**CHEMETRON CORPORATION**

Your letter of December 23, 1993 to Mr. David R. Sargent forwarded the NRC's comments on our "Site Remediation Plan - Harvard and Bert Avenue Sites" Revision 0, dated October, 1993. Your letter also included comments from Mr. Todd Brady of the Cuyahoga County Board of Health.

CUYAHOGA COUNTY BOARD OF HEALTH COMMENTS  
ON  
SITE REMEDIATION PLAN CHEMETRON REMEDIATION  
HARVARD AND BERT AVENUE SITES

US NUCLEAR REGULATORY COMMISSION  
COMMENTS ON CHEMETRON FINAL REMEDIATION PLAN

ATTACHMENT 4

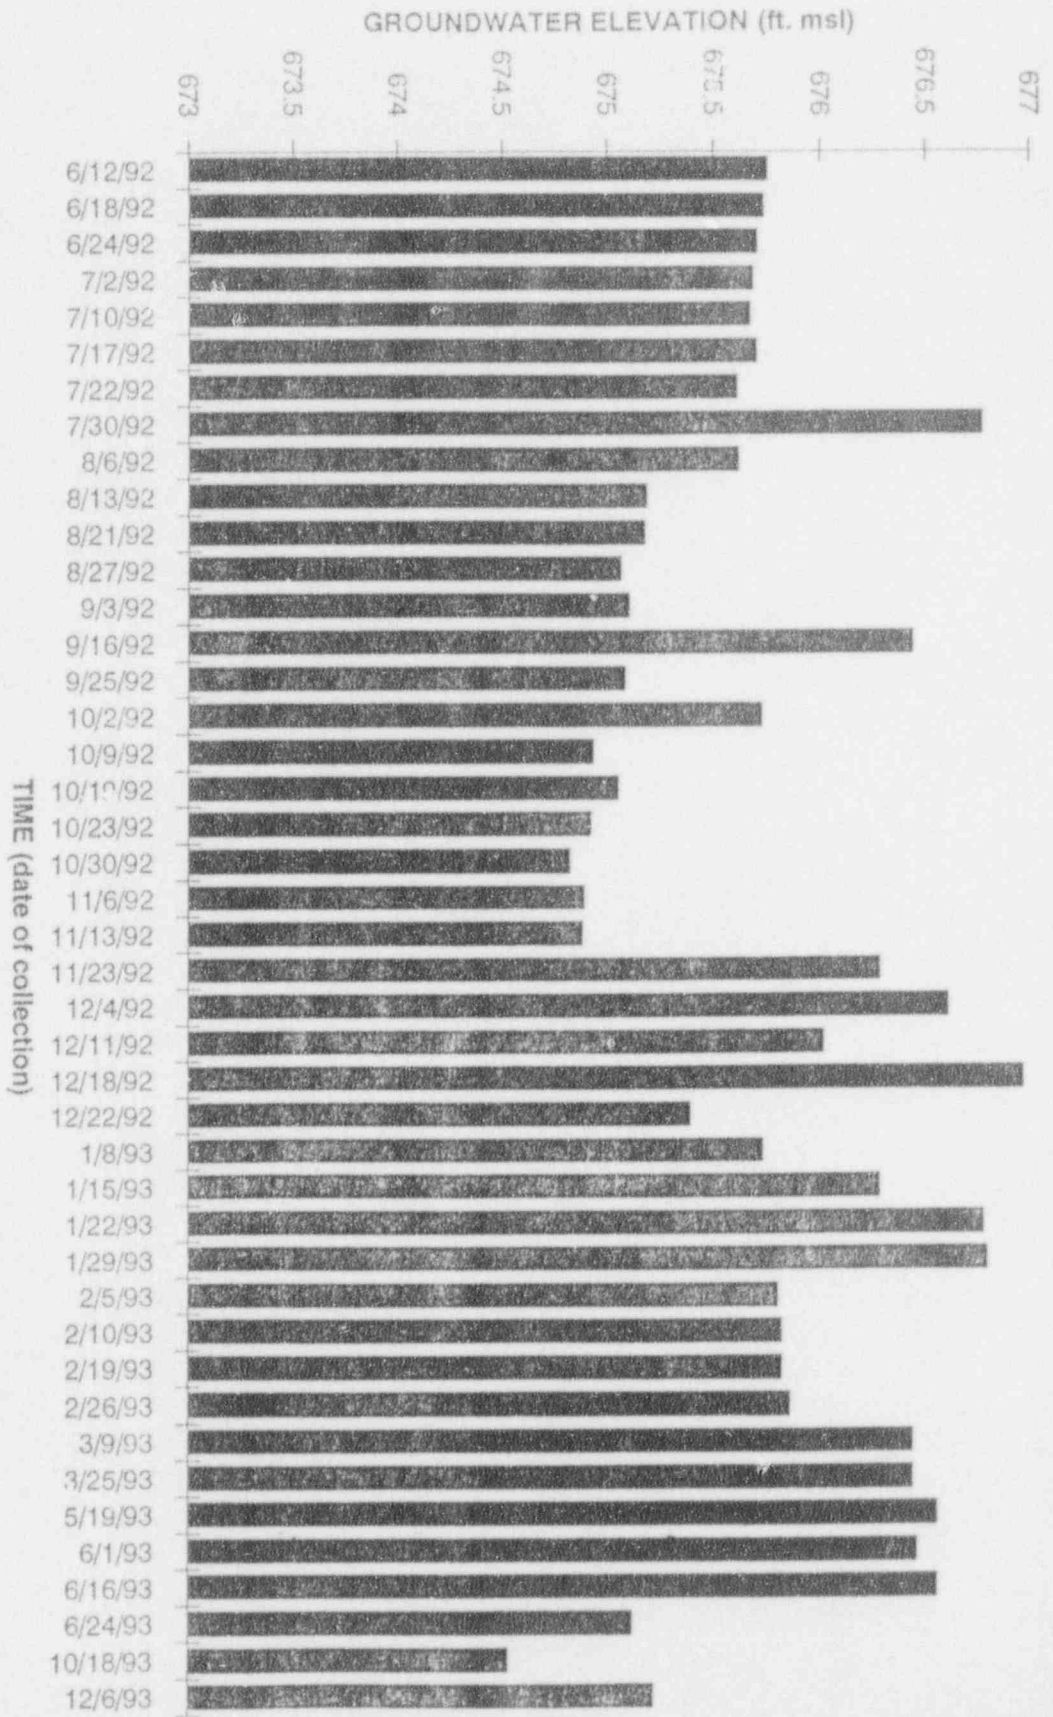
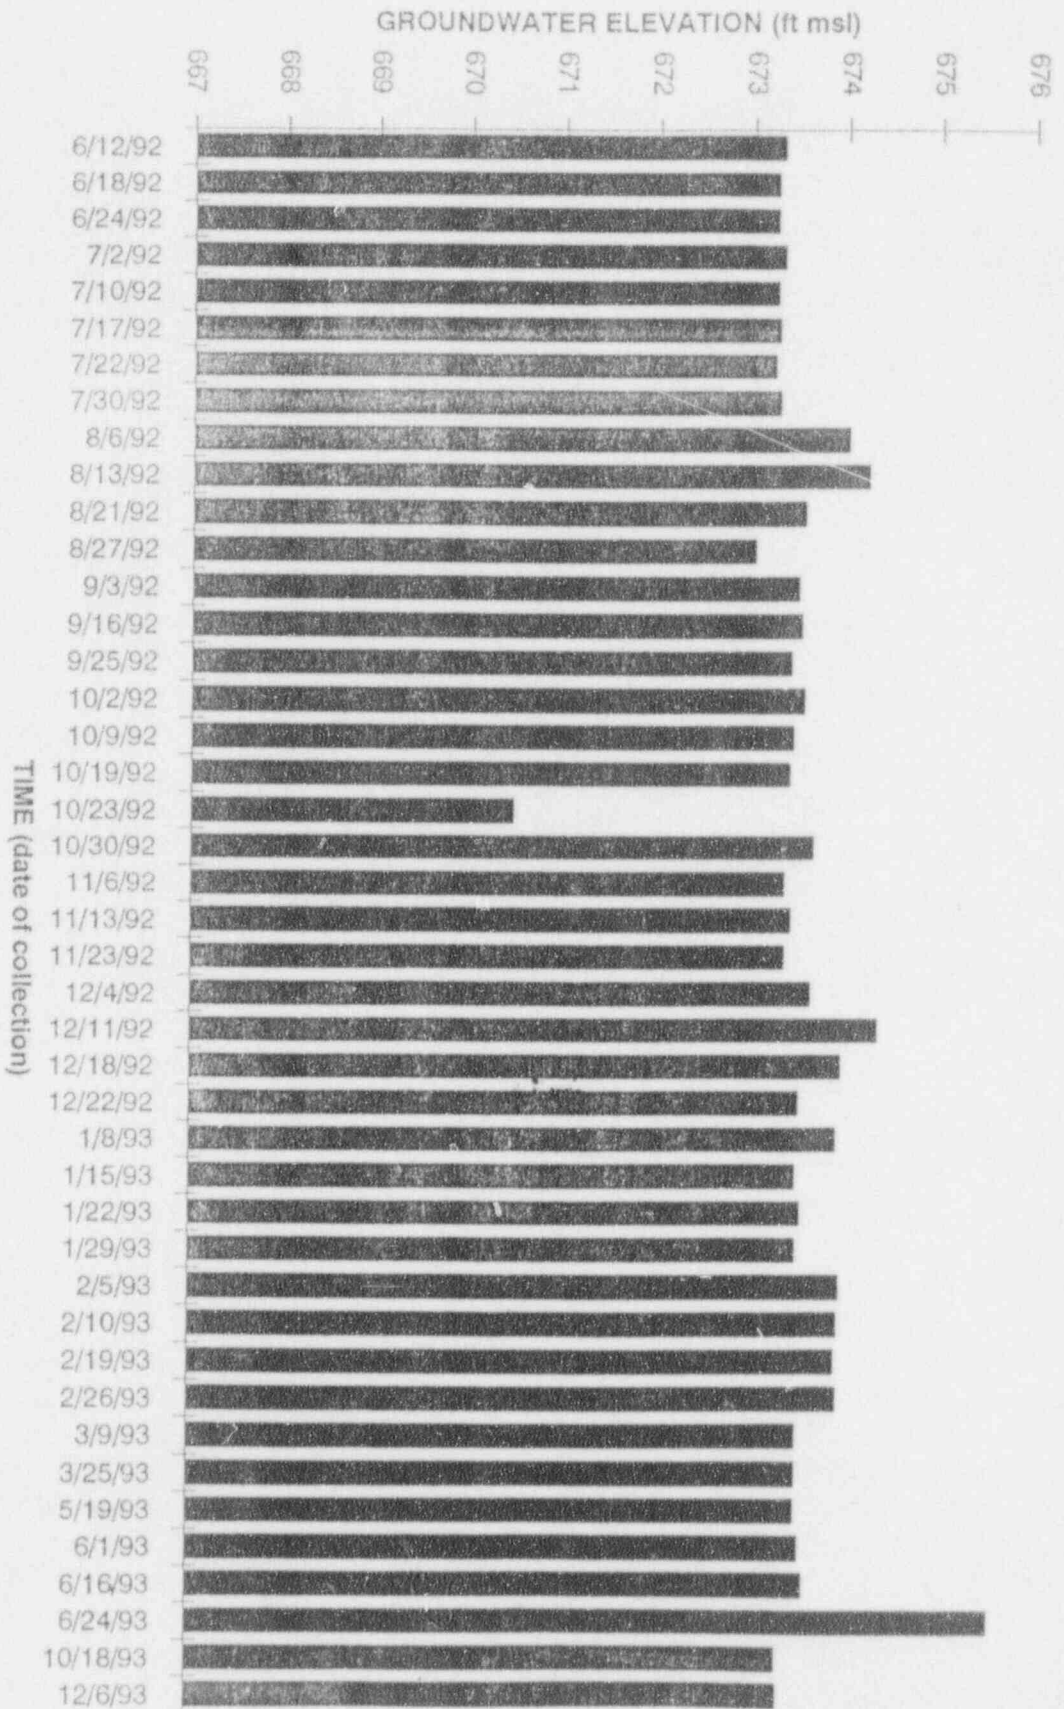
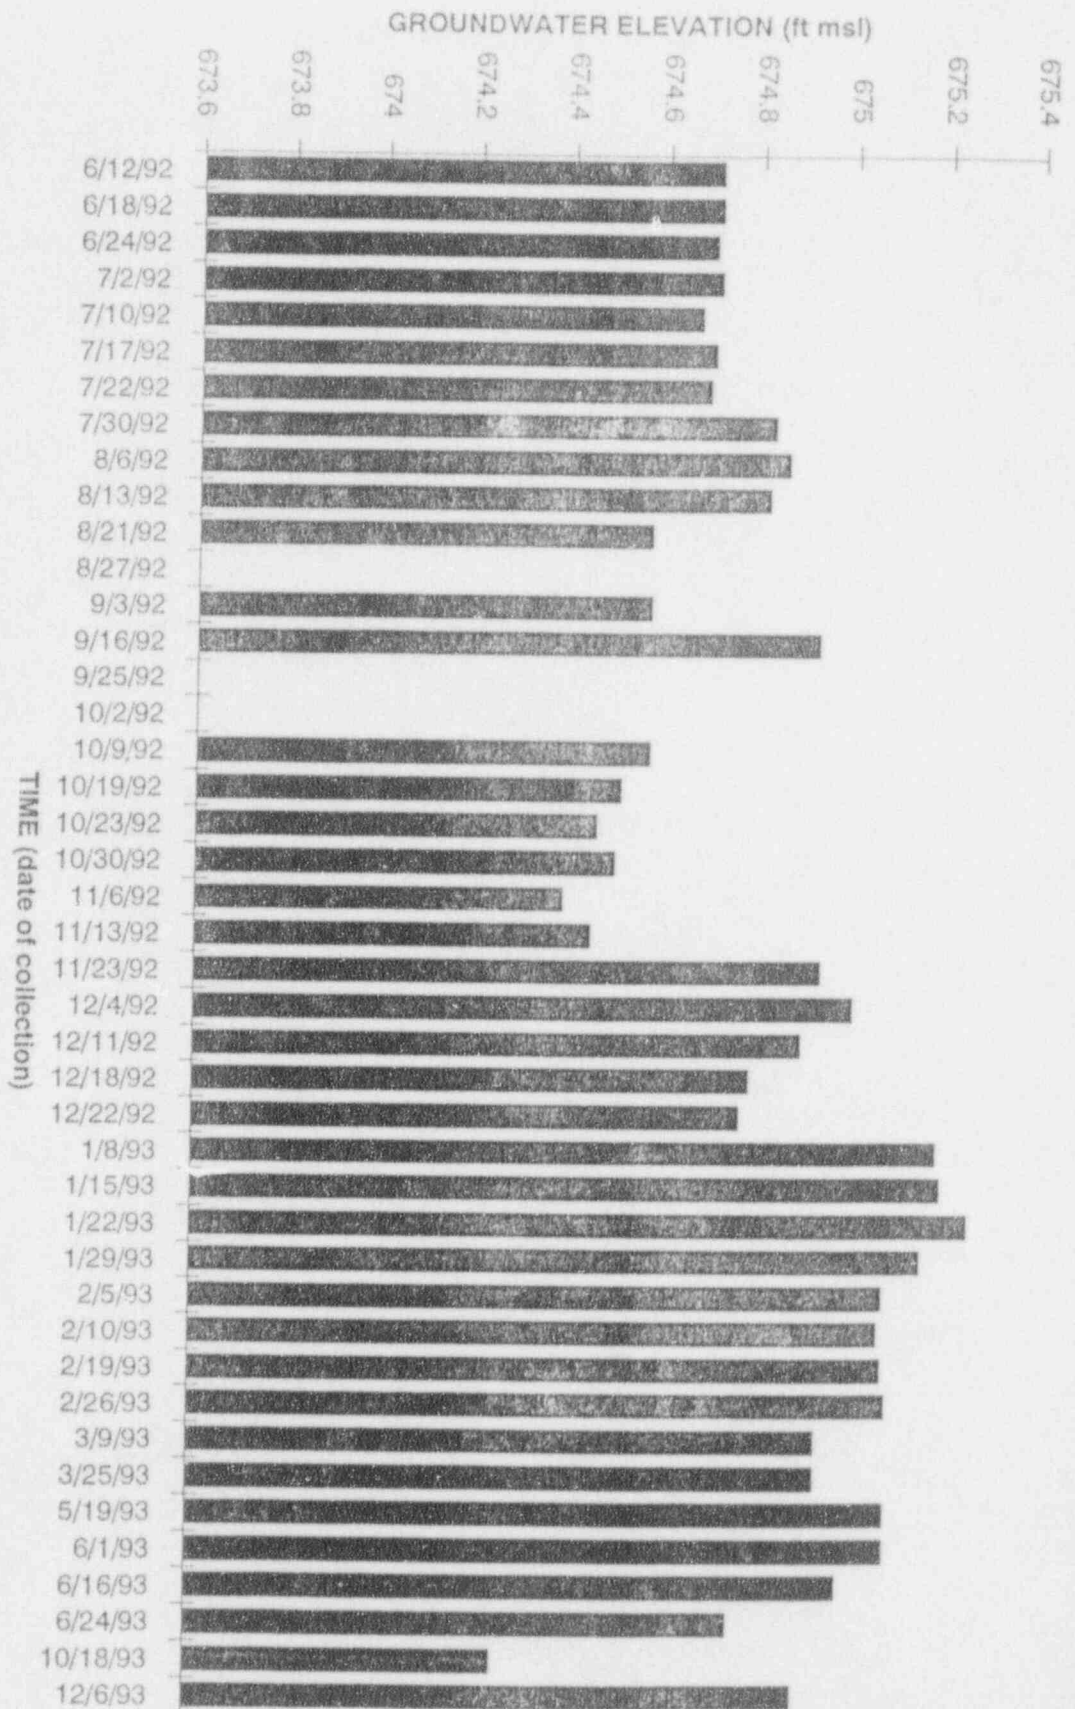
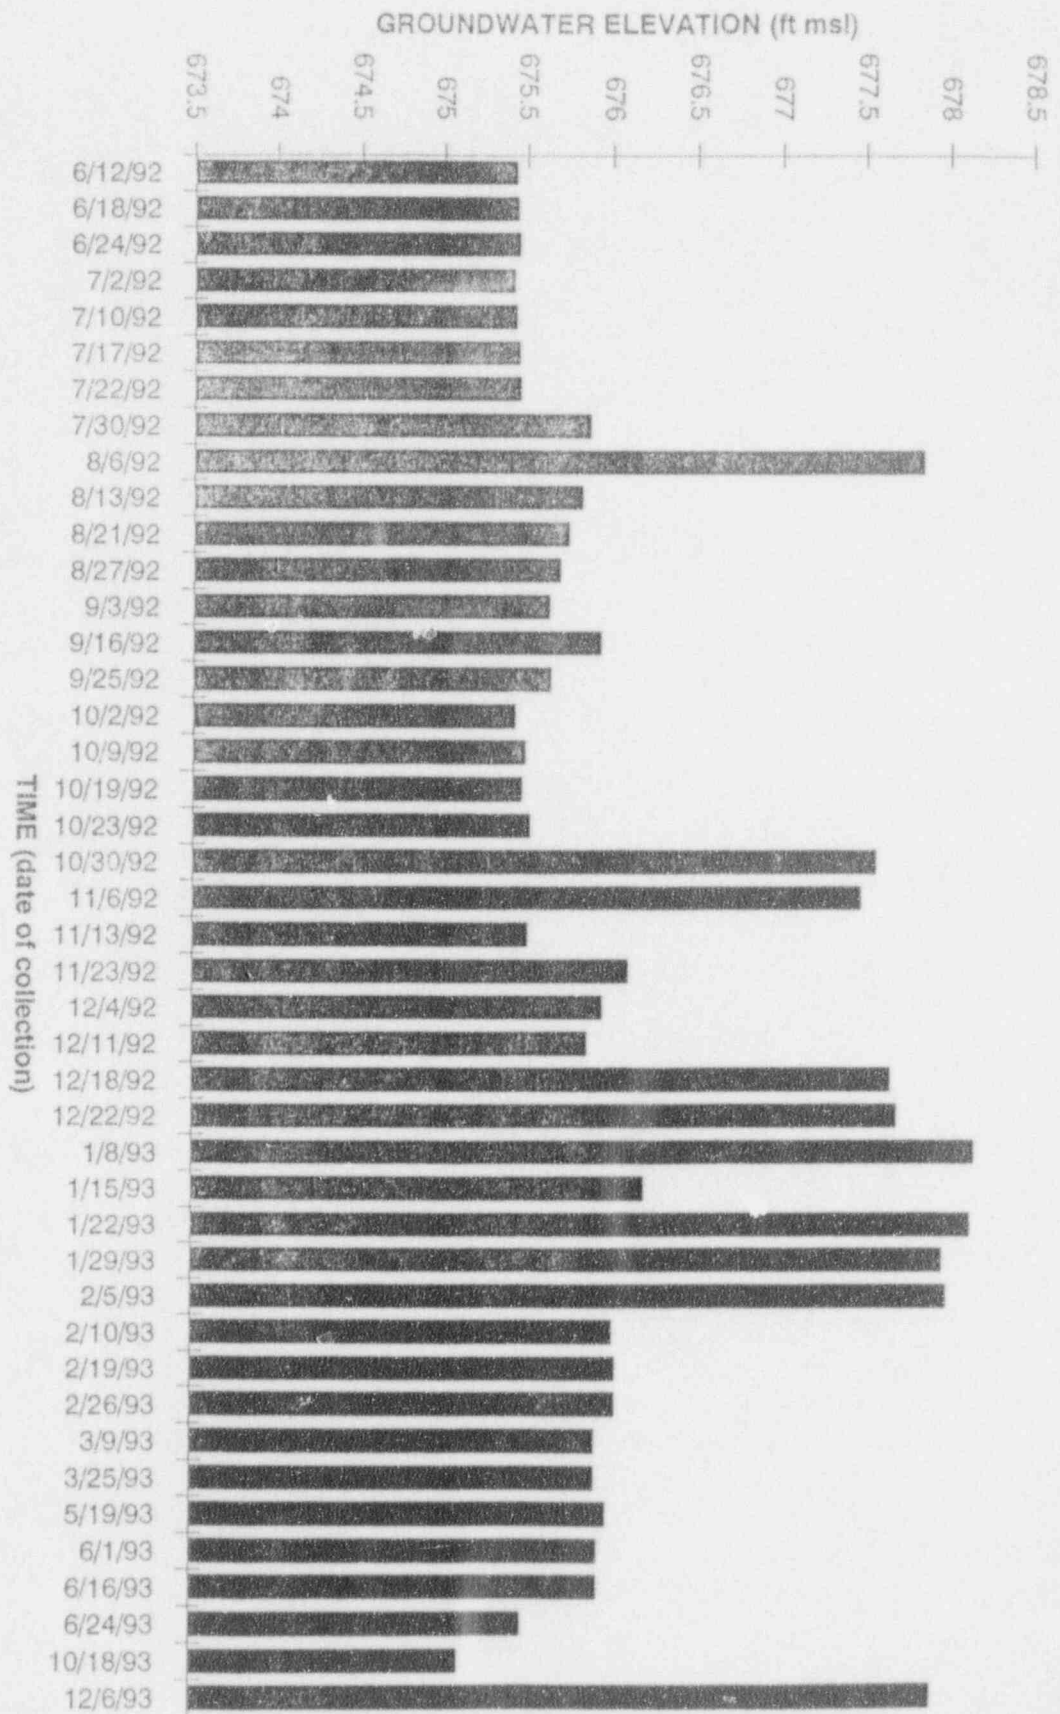
Please provide the groundwater data and hydrographs that support your temporal fluctuation conclusions.

**Response:** Paragraph 2 presents the groundwater data for Harvard Avenue, and will be revised to specify that point. Groundwater hydrographs are included as Attachment 4 and will be included in the Remediation Plan to present the groundwater elevation trends.
